**Offsite Dose Calculation Manual Changes and Justification Packages, 2008**

ENTERGY NUCLEAR OPERATIONS, INC  
INDIAN POINT NUCLEAR GENERATING UNIT NOS. 1, 2, and 3  
DOCKETS 50-3, 50-247 and 50-286

# IPEC COMBINED ODCM Rev 1 Justification Package

**ENVIRONMENTAL SAMPLING POINTS**

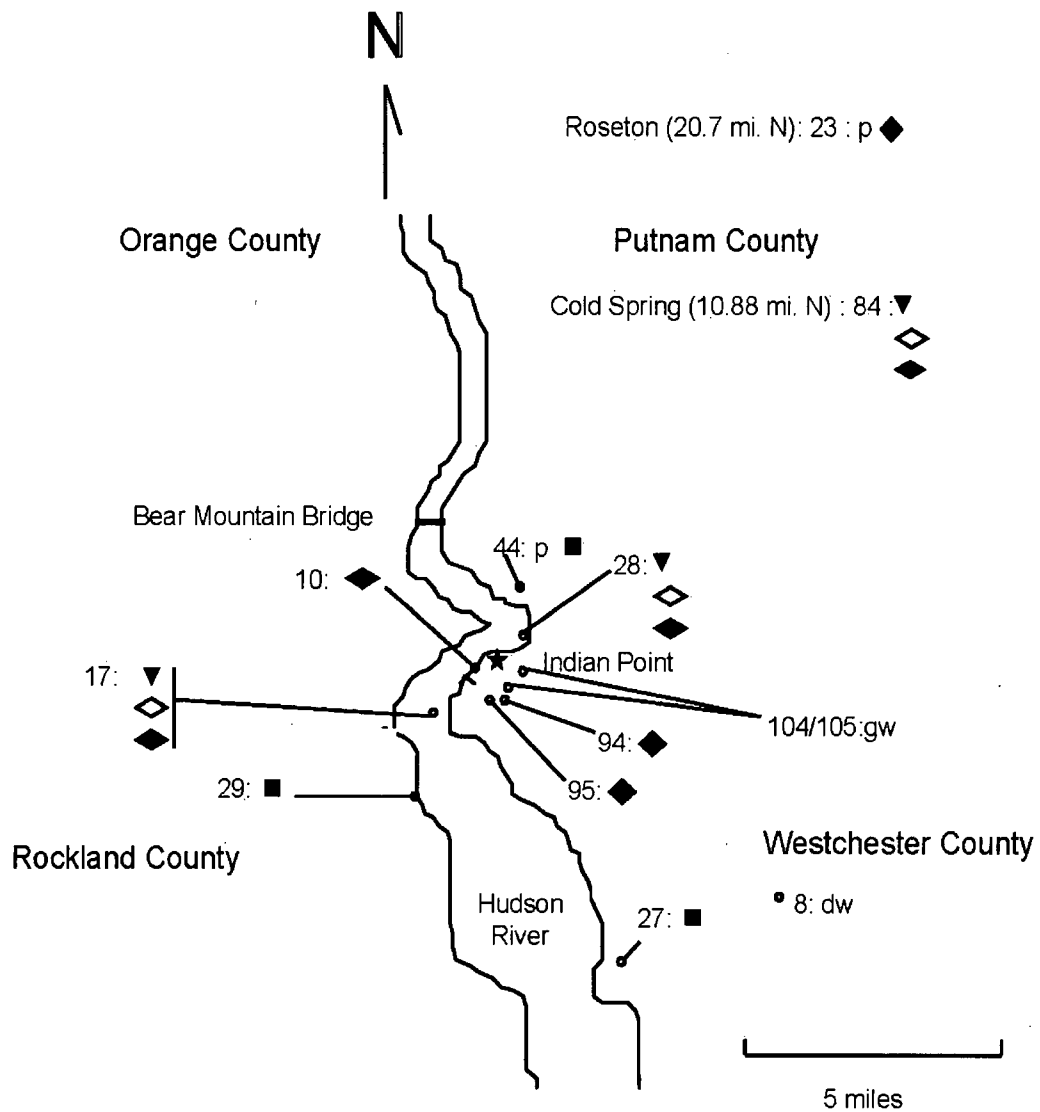
Remove the abandoned and non-required air sampling station at the old Lovett Power Station, Appendix G, pages 3 and 7.

This station was never required. Upon closing of the Lovett power plant, its use or potential relocation was considered. Twenty years of data have identified this location to offer no relevant MET data. While the LACK of any airborne activity at this location is valuable information, the instrumentation has already provided that function. Had this been the only station in excess of requirements, the decision may have been to relocate it.

However, since Lovett power plant is being dismantled, and the fact that we STILL have three more stations in the field beyond what is required by RECS 3.5.1 (and NUREG 1301), this station is simply being removed. The RECS require 3 sample locations at highest calculated D/Q values, another at the established year-round local community, and a fifth at the control location. IPEC still employs 3 more samplers in addition to these, as a means of demonstrating sincere efforts to exceed minimum standards. It was therefore agreed to simply remove the station at Lovett.
